Date: 28th February 2018
Our Ref: P1164-4-0010

Re: Kilmessan Quarry Waste Licence Application, Co. Meath – Response to certain Article 14 Items – (EPA Reg No. W0296-01)

Hydro-Environmental Services (HES) were requested by Kilsaran Group to respond to certain hydrological items from an Article 14 request from the EPA in respect of Waste Licence Application W0296-01.

Figure B: Temperature of Quarry Discharge

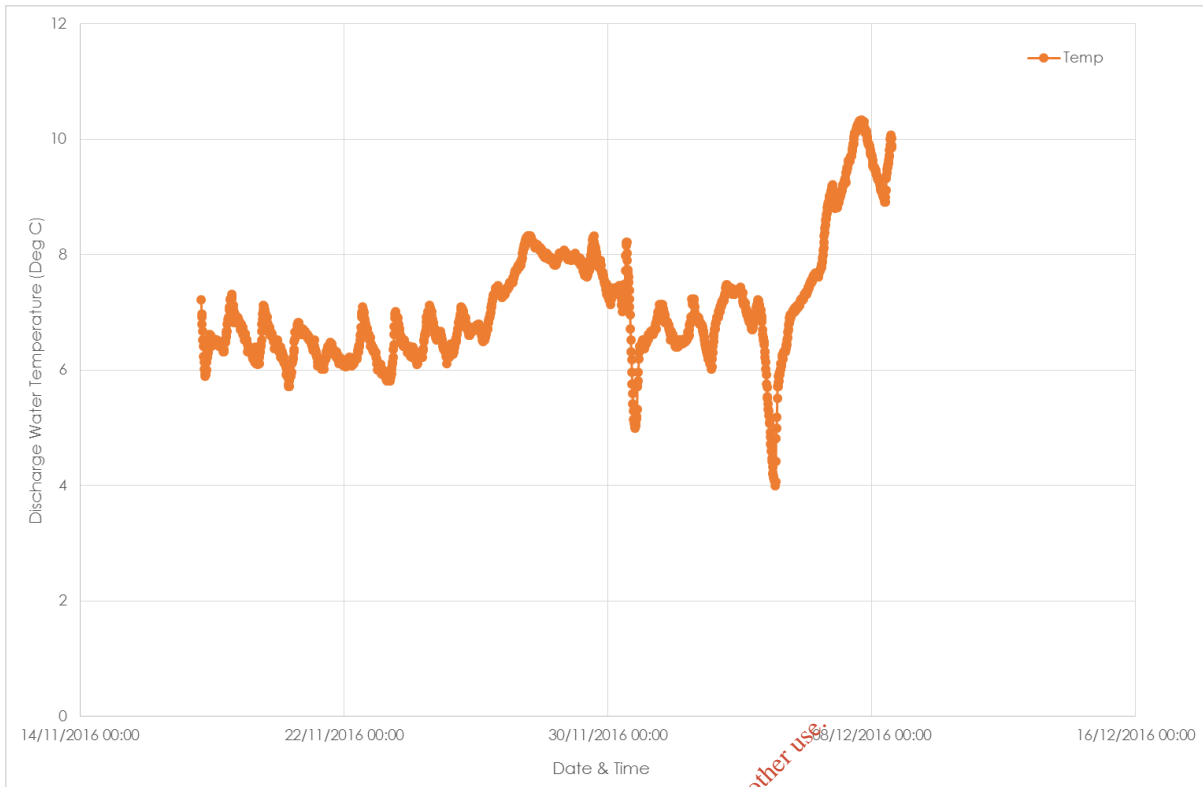
Item 11 *"Provide an analysis that demonstrates that the low temperature of the pumped water will not have an impact on species and habitats in the Balreask Stream and Skane River"*.

However, the water being discharged from the site is of relatively stable temperature (the water being mainly groundwater), and it also has little impact on temperature in the receiving water.

There is a water level data logger located at the settlement pond outfall v – notch weir for continuous measurement of quarry discharge. This data logger is also capable of recording quarry discharge water temperature. Based on the data logger records, the average temperature of quarry discharge during winter (Nov – Feb) is approximately 6.9°C (min: 4.0 °C, max 10.4 °C). These data are plotted on **Figure B** below.

Therefore, as a result of the above data plots and assessment, there will be no significant effects on species and habitats in the Balreask Stream and Skane River relating to temperature of the proposed existing quarry discharge.

APPENDIX II CHANNEL SURVEY

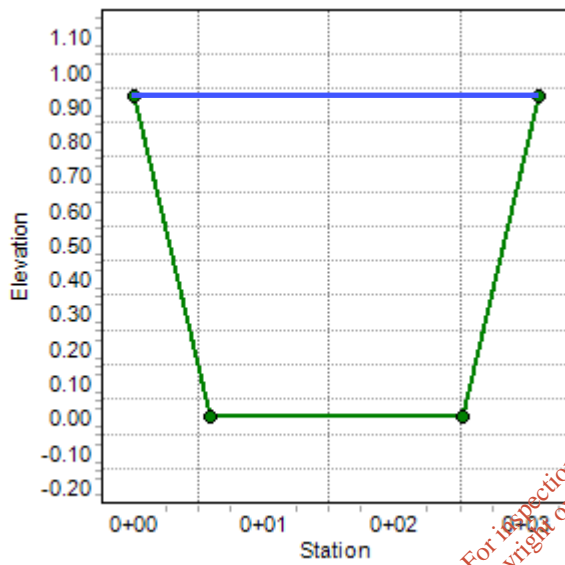
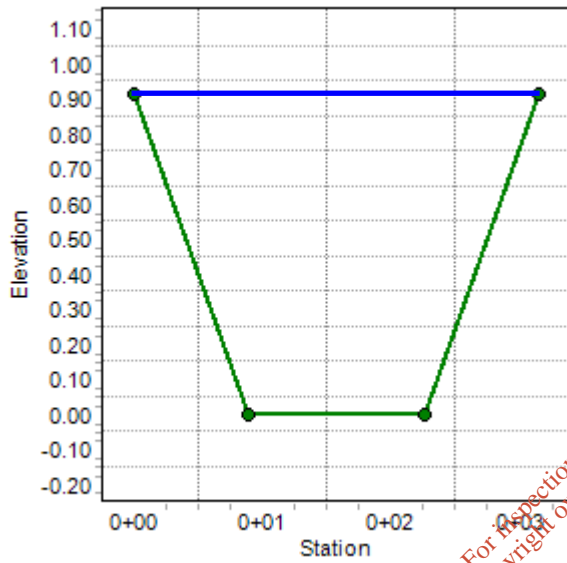
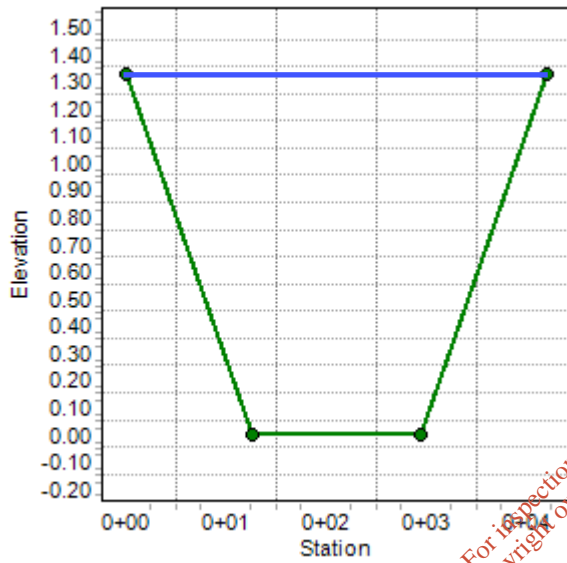
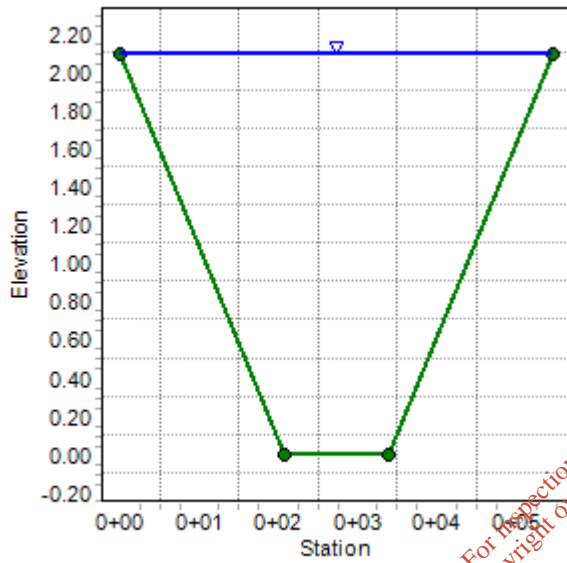
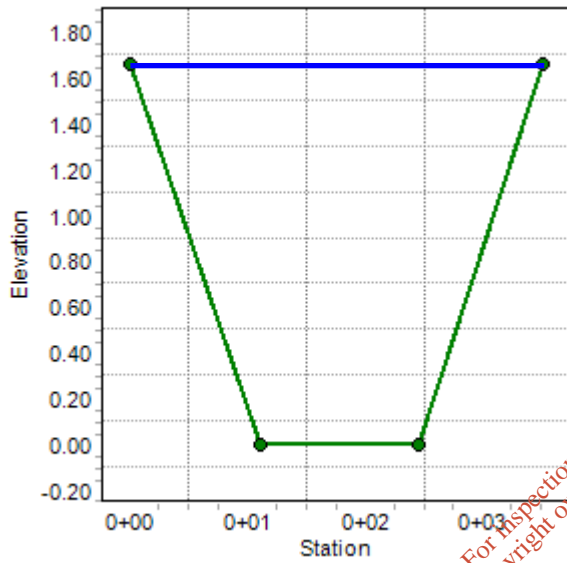
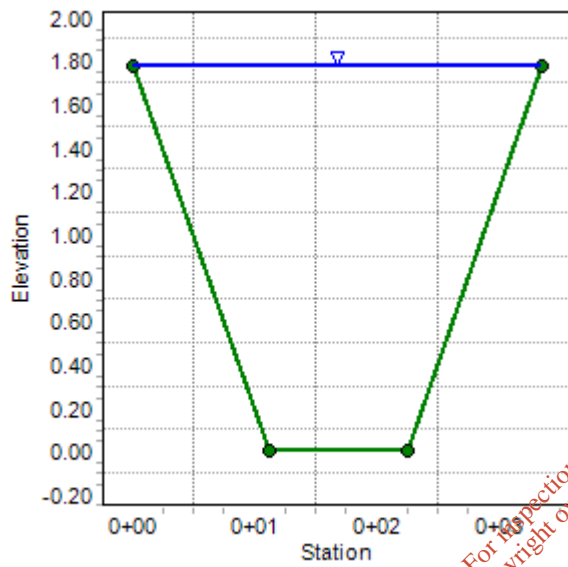
Item 10 *"Provide a hydraulic model of the volumetric discharge from the pumping of the quarry so that there is sufficient evidence to demonstrate that the pumping will not cause flooding in the ephemeral stream (EPA Name: Balreask Stream) or Skane River downstream. Proposed volumetric pumping limit values, seasonally varied if necessary, that are not disruptive to the natural environment regarding protection of species and habitats and contribution to flood risk"*.

The channel cross-sections were modelled in Flowmaster (proprietary hydraulic modelling analysis software) to determine the maximum channel capacity at each of the channel survey locations.

There was no exceedance of channel capacity during the Q_{med} or 100-year peak flow at any of the cross-section locations.

Most importantly, the surplus channel capacity (as shown in **Table B** below) is well in excess of the peak quarry discharge ($5,500\text{m}^3/\text{day}$ or $0.064\text{m}^3/\text{s}$), and all sections are capable of transmitting this additional flow.

The hydraulic modelling of the Balreask Stream demonstrates that quarry pumping will not cause flooding in the ephemeral stream (Balreask Stream) or the downstream Skane River.
